Audio System Cuts Out When Using Right Turn Signal While Playing FM Radio

2018 Accord

FERRITE CORE
WRAPPED WITH FOAM

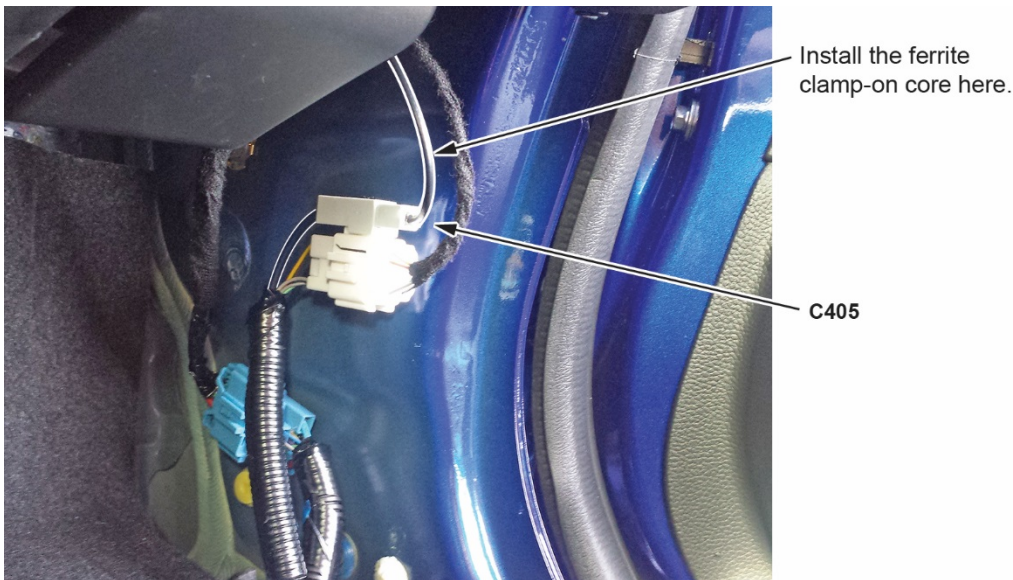
We're currently looking at an issue where the audio system cuts out when using the right turn signal while playing FM radio. Until we come up with a permanent solution, here's a temporary fix that's quick and easy and will prevent cutting out the noise:

1. Remove the passenger side kick panel, and find connector C405.
2. Install a ferrite clamp-on core on the black coax cable leading to the dashboard, near the connector.

3. Wrap the core with foam tape to prevent contact with the surrounding area.
